**CITY OF CALLAWAY  
GORE PARK SITEWORK  
BID NO.: LS2022-06**

**ADDENDUM #3**

Date Issued: March 9, 2022

# POLE FOUNDATION ELEV.

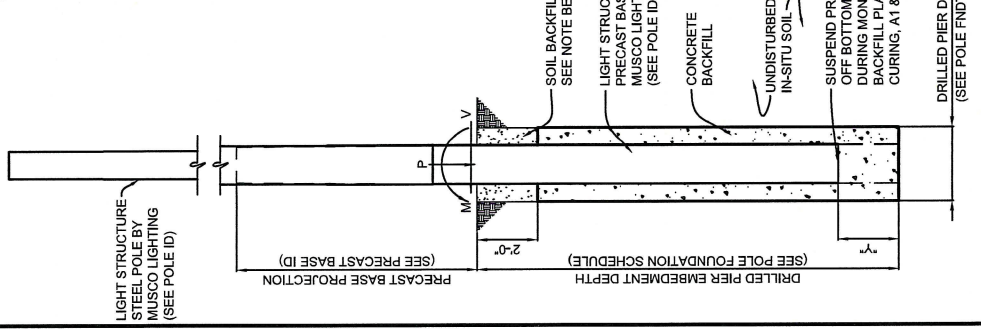
2. We have the sheet on the poles out of the specs from Musco. Poles labeled F1 – F4 and P1 – P4 do NOT have a reference on the pole assembly drawing pertaining to the concrete back fill. What detail are we to use?

**See attached for the Pole and Foundation Design Drawing No. Sheet C1.**
